**Sewage Lagoon  
Grise Fiord, NWT**

At your request, we have reviewed the tender drawings for the above project. The review was limited to the information shown on the drawings with respect to construction details. Sewage effluent/treatment data was not provided and, as such, we have not commented on the treatment process. Further, regional hydraulics were not reviewed and, therefore, drainage channel capacity is not discussed in this letter. Our comments are as follows:

- Drawing 100 - Site Plan

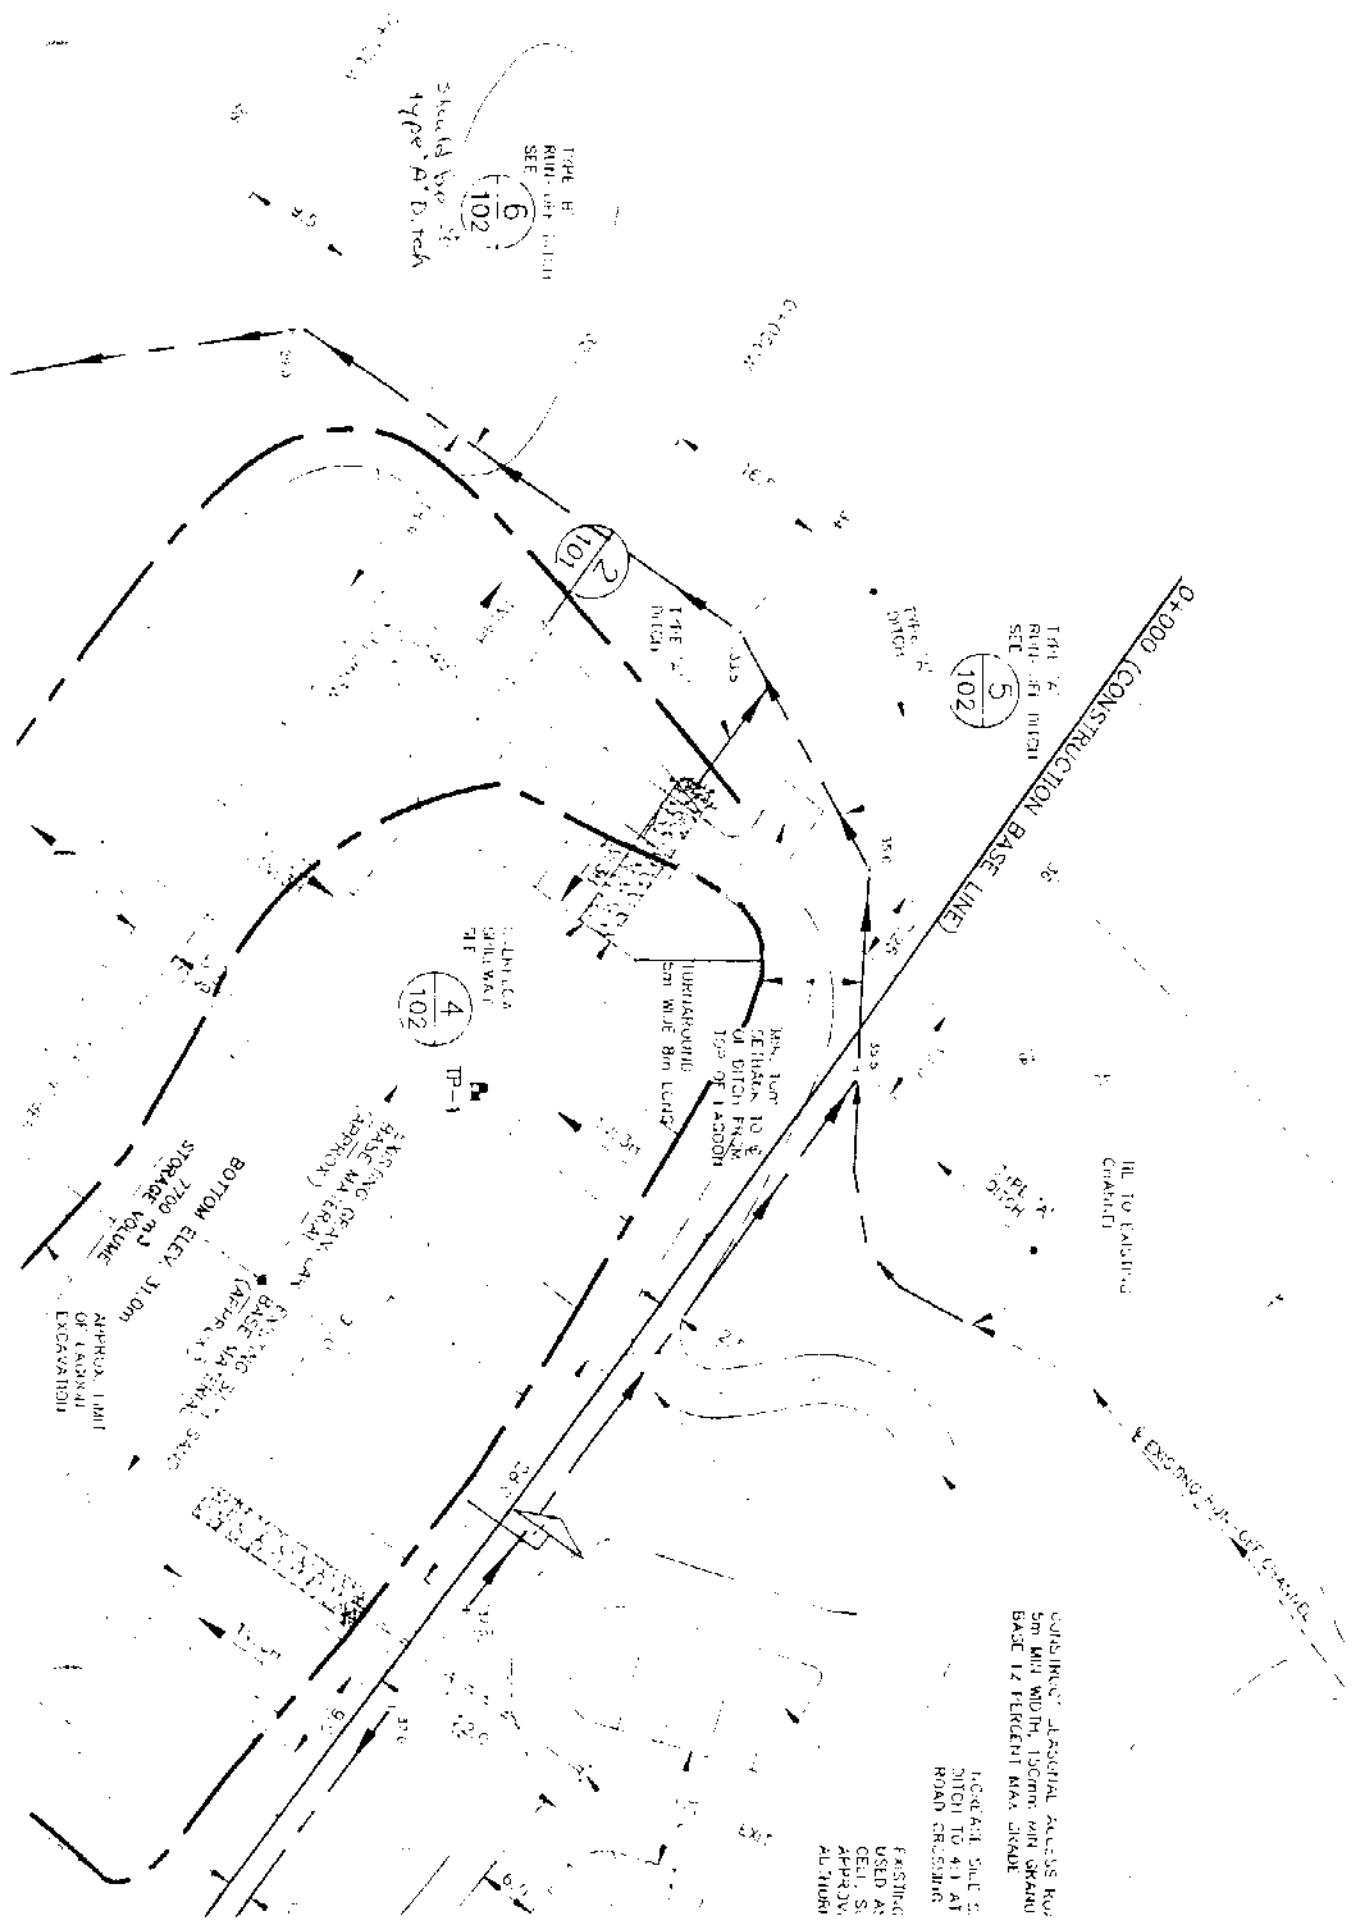
The ditch downstream of the overflow spillway is shown to be a Type B ditch. It is assumed that the lagoon will be discharged to this ditch. The frozen core dyke design precludes discharging by exfiltration.

Erosion protection along the discharge ditch should be considered. This is shown be a Type A ditch on the plans. We suggest that the Type A ditch would be more appropriate for the discharge channel.

- Drawing 101 - Detail 1 and Detail 2

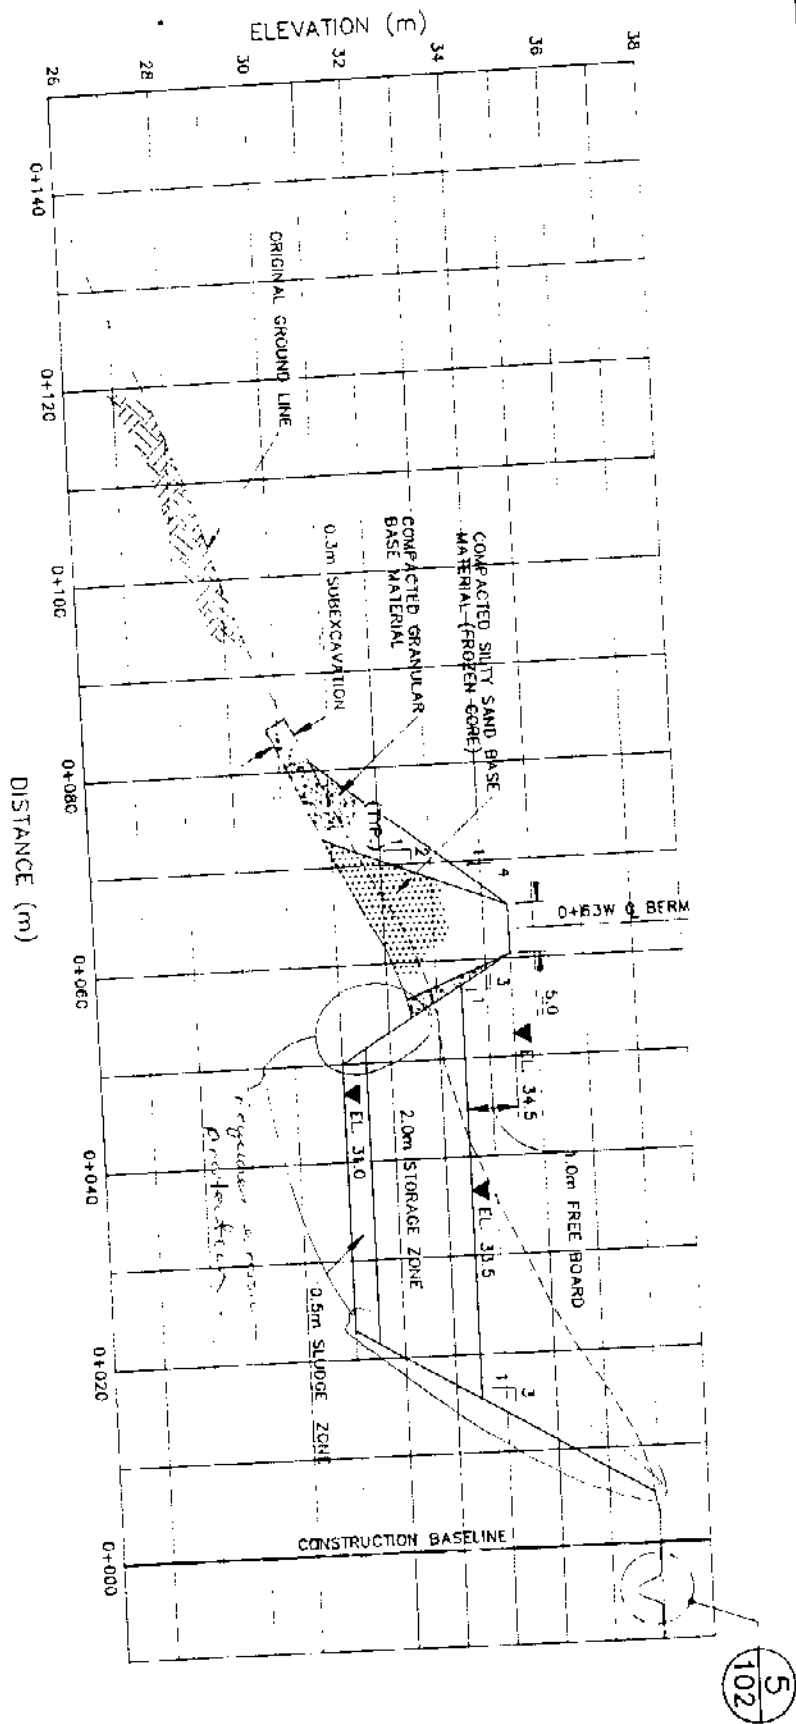
The berm walls are shown to be constructed of a partial excavation and a partial fill section. In areas on the interior slopes that are an excavation section, there is no treatment of the face shown.

The drawings indicate that this material is a frozen, silty material for approximately half of the lagoon area. This material will thaw at the face of the slope. Consideration should be given to removing 1.0 m of this material and placing compacted, granular material over all interior faces. The granular material will aid in preventing erosion and, therefore, increase the stability of the berm walls.
